**IN THE DRAWINGS:**

## REMARKS

This is intended as a full and complete response to the Office Action dated February 24, 2006, having a shortened statutory period for response set to expire on May 24, 2006. Please reconsider the claims pending in the application for reasons discussed below.

FIG. 1

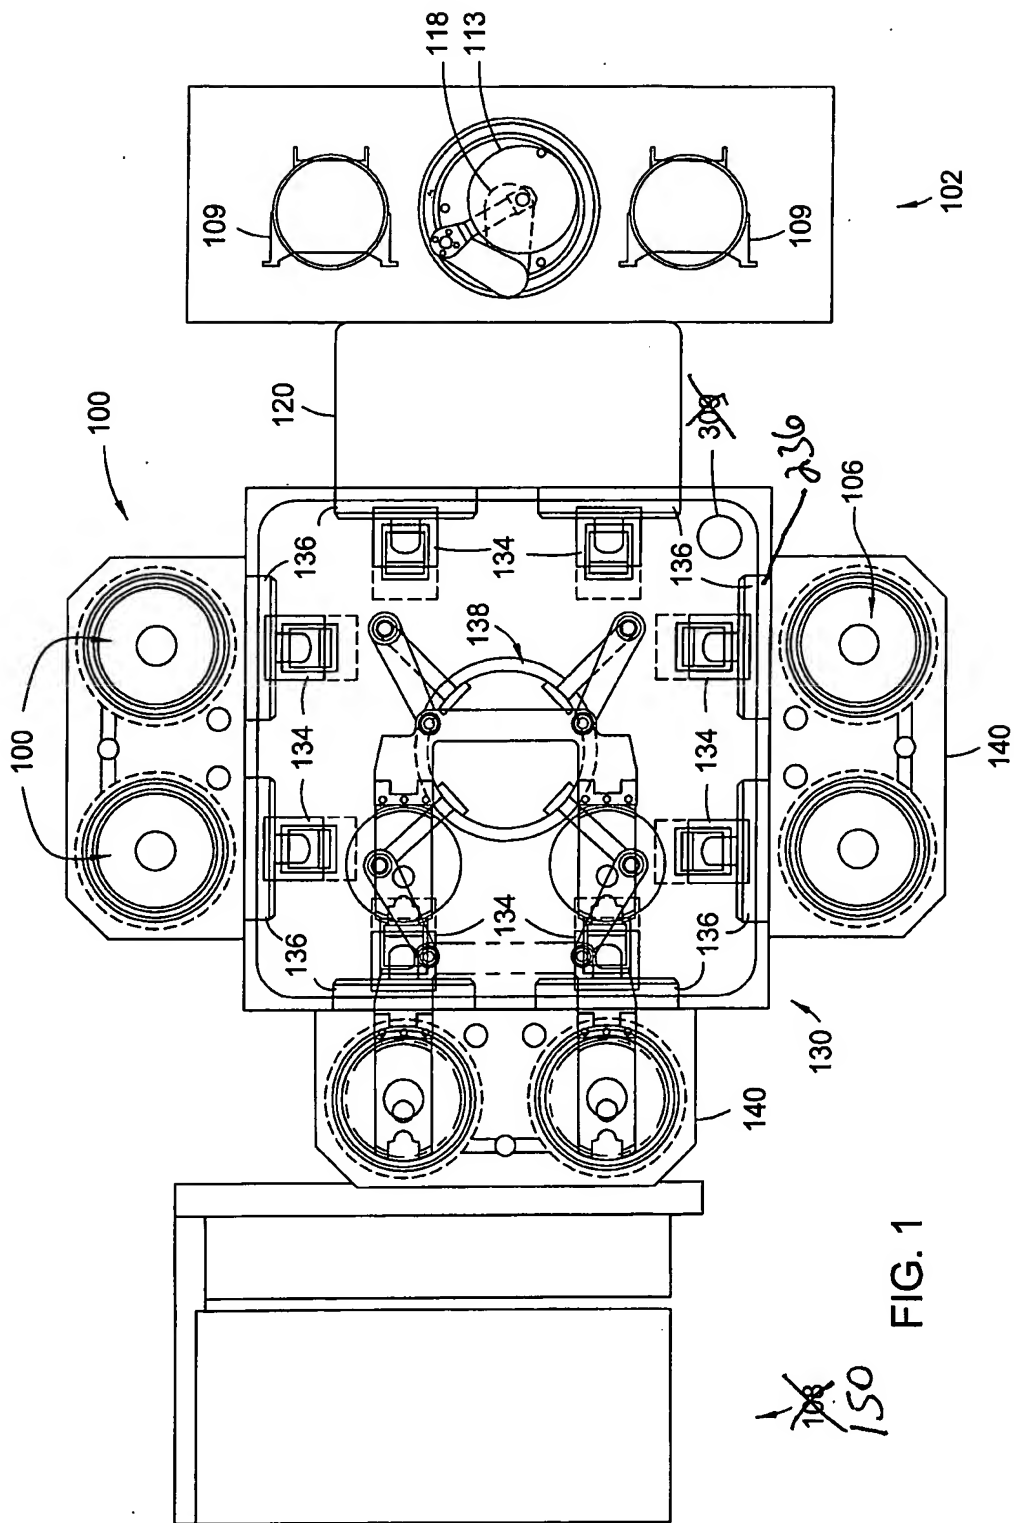
The attached two sheets of drawings include changes to Figures 1 and 6B. These sheets, which includes Figures 1 and 6B, replace the original sheets including Figures 1 and 6B. In Figure 1, previously omitted element 236 has been added, element 309 has been deleted, and element 108 has been changed to 150. In Figure 6B, an extraneous element 422 has been deleted.

In amended Figures 1 and 6B, the previously omitted element numerals 150 and 236 have been added, while extraneous element numerals 309, 108, and 422 have been deleted.
